## Product Change Notice (PCN)

PCN Number: PCN-0454736R-01

Product(s) Affected: SJ2-2577X-SMT-TR Series.

SJ2-25774B-SMT-TR. SJ2-25774A-SMT-TR & SJ2-25773B-SMT-TR

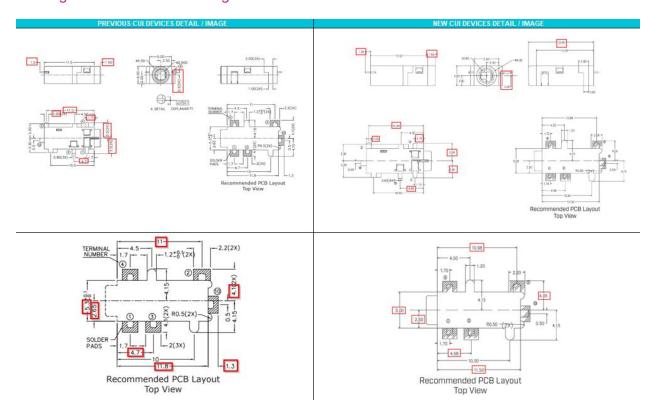
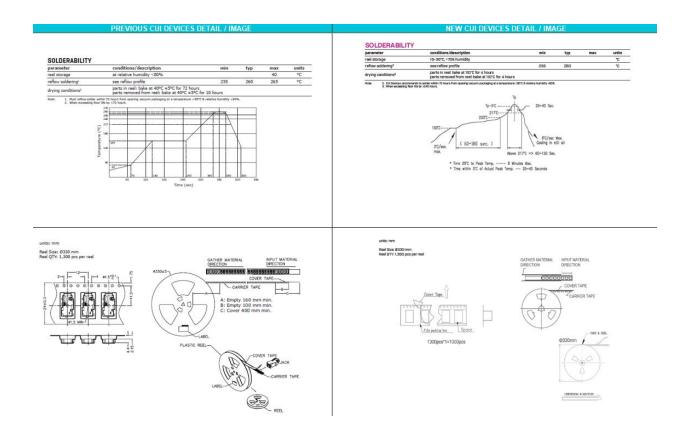
Description of Change: Minor Housing and footprint differences. Material Change on the housing and terminals. See image Below

MATERIAL	PLATING	
terminal 1	copper alloy	silver	
terminal 2	copper alloy	silver	
terminal 3	copper alloy	silver	
terminal 4	copper alloy	silver	
terminal 10	brass	silver	
plastic	PA10T

NEW CUI DEVICES DETAIL / IMAGE				
DESCRIPTION	MATERIAL	PLATING/COLOR		
terminal 1	brass	silver		
terminal 2	brass	silver		
terminal 3	brass	silver		
terminal 4	brass	silver		
terminal 10	brass	silver		
housing	PA10T (UL94V-0)	black
